RESTORE MOBILE GEORGE STREET SUBDIVISION

Engineering Comments: FINAL PLAT COMMENTS (should be addressed prior to submitting the FINAL PLAT for review and/or signature by the City Engineer):

APPLICATION NUMBER 6 DATE September 20, 2018

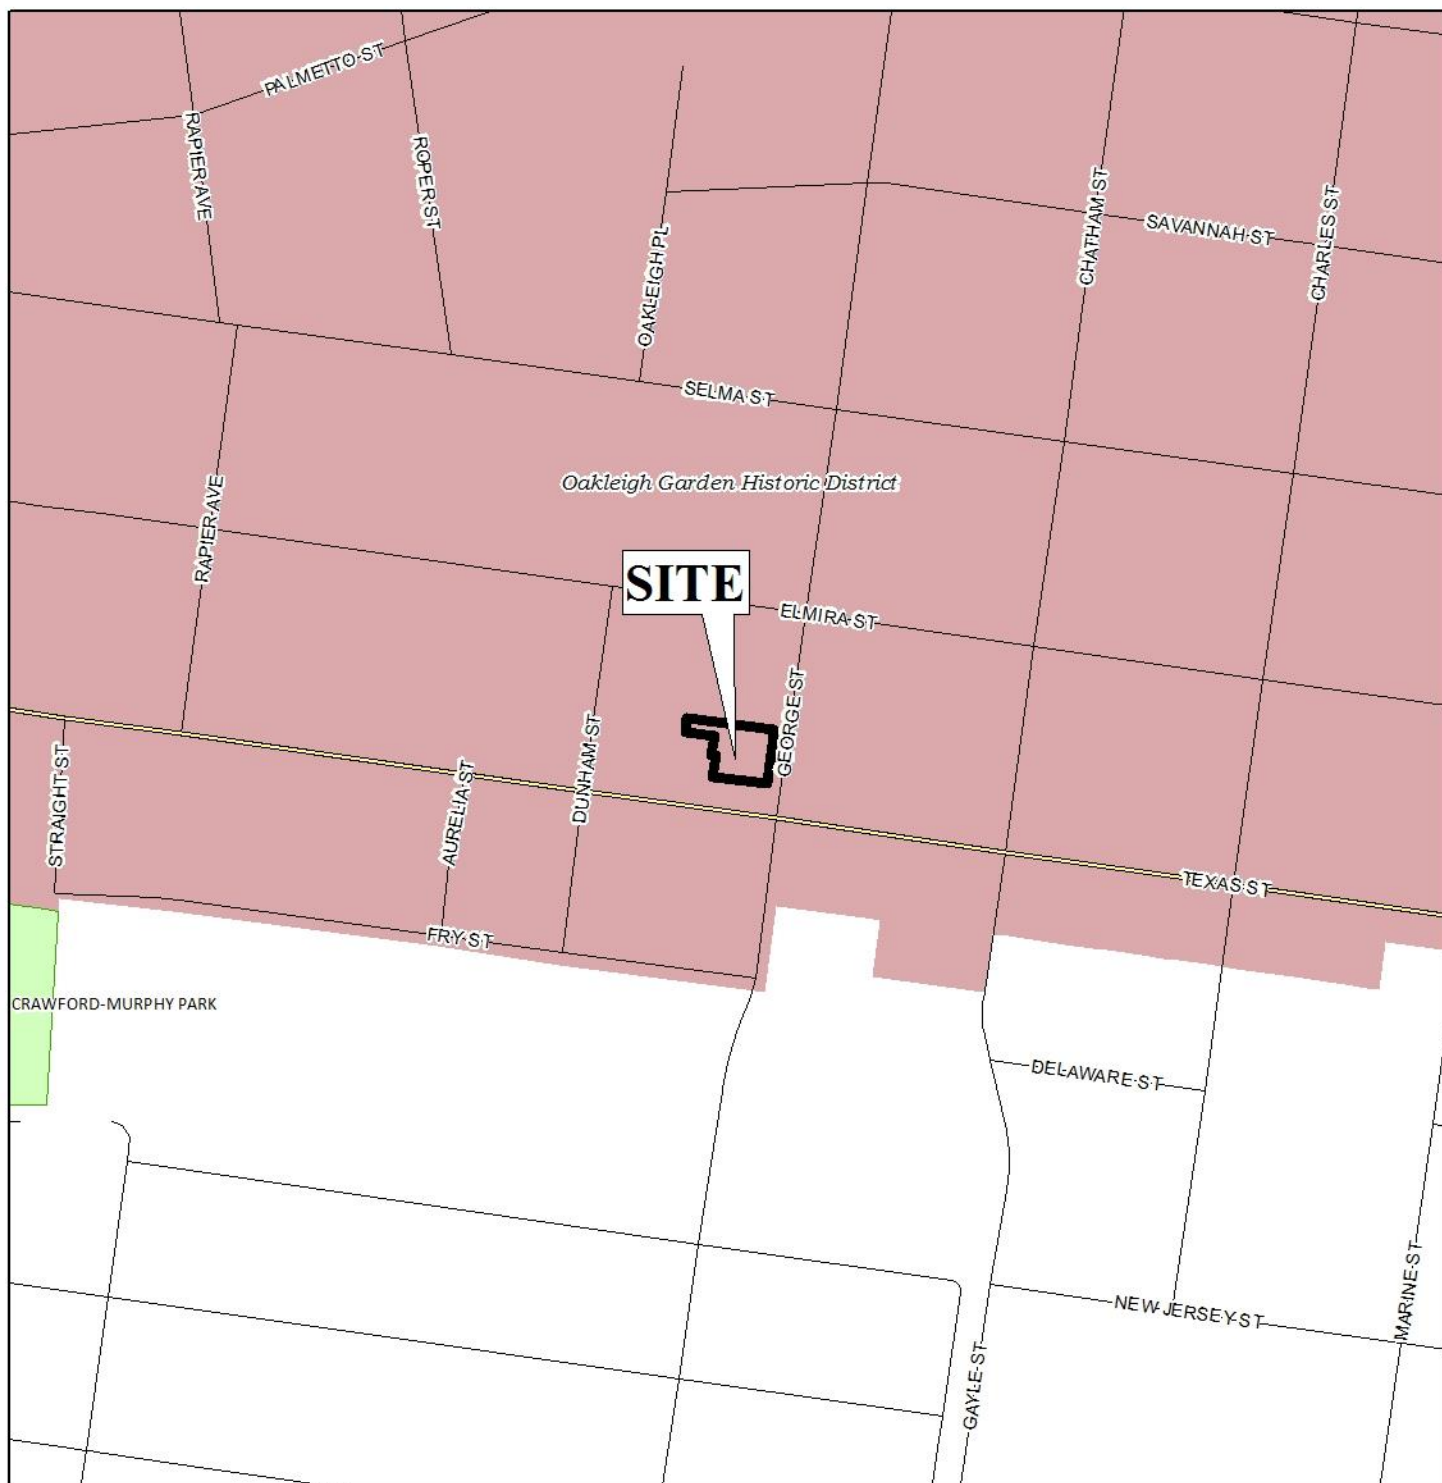
The proposed lots front George Street, a minor street requiring a 50' right-of-way width. The preliminary plat illustrates a 50' right-of-way width and, if approved should be retained on the Final Plat.

A 25-foot minimum building setback line is depicted on the preliminary plat along George Street for the proposed Lot 1 and 2. If approved, the 25-foot minimum building setback should be retained on the Final Plat.

The proposed lots do not meet the 7,200 square foot minimum lot size requirements for lots served by public water and sanitary sewer systems. Given that the site is in the Oakleigh Garden Historic District, substandard size lots are common, therefore a waiver of V.D.2. of the Subdivision Regulations may be appropriate. The preliminary plat provides the lot size in square feet and acres. If approved, the lot size information should be retained in square feet and acres on the Final Plat.

As a means of access management, a note should be placed on the Final Plat, stating that each lot is limited to one curb cut, with size, location and design to be approved by Traffic Engineering and conform to AASHTO standards.

- 1) Retention of the 50' right-of-way width for George Street;
- 2) Retention of the 25' minimum building setback line along George Street;
- 3) Retention of lot size information in both square feet and acres;

- 4) Placement of a note on the Final Plat stating that each lot is limited to one curb cut, with the size, design and location to be approved by Traffic Engineering and conform to AASHTO standards;
